## SERVICE INFORMATION NO. SI 40NG-027

EASA Airworthiness Directive No. 2013-0025R1 and Austro Engine Mandatory Service Bulletin MSB-E4-007/4

# MANDATORY SERVICE BULLETIN

Replacement of Waste Gate Controller

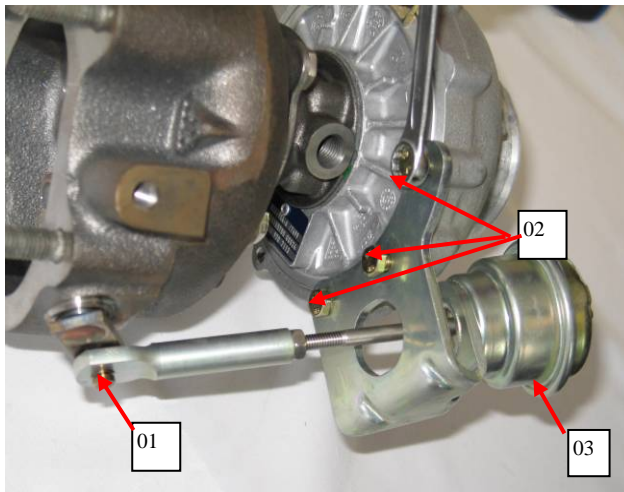
Removal of installed Waste Gate Controller:

1. Disconnect Hose at the top of the Waste Gate Controller
2. Remove three M6 Bolts [02]
3. Remove Circlip [01]
4. Disconnect rod from waste gate lever and remove waste gate controller [03]

1. Install the three M6 Bolts [02] and torque them with 7 Nm
2. Attach external pump to the top of the Waste Gate Controller and apply pressure till the rod starts to move
3. Connect rod to waste gate lever
4. Adjust Waste Gate Controller according to Engine Maintenance Manual E4.08.04, Chapter 81-00-32.

**Note:** For fixing of the rod on the waste gate lever use new circlip.
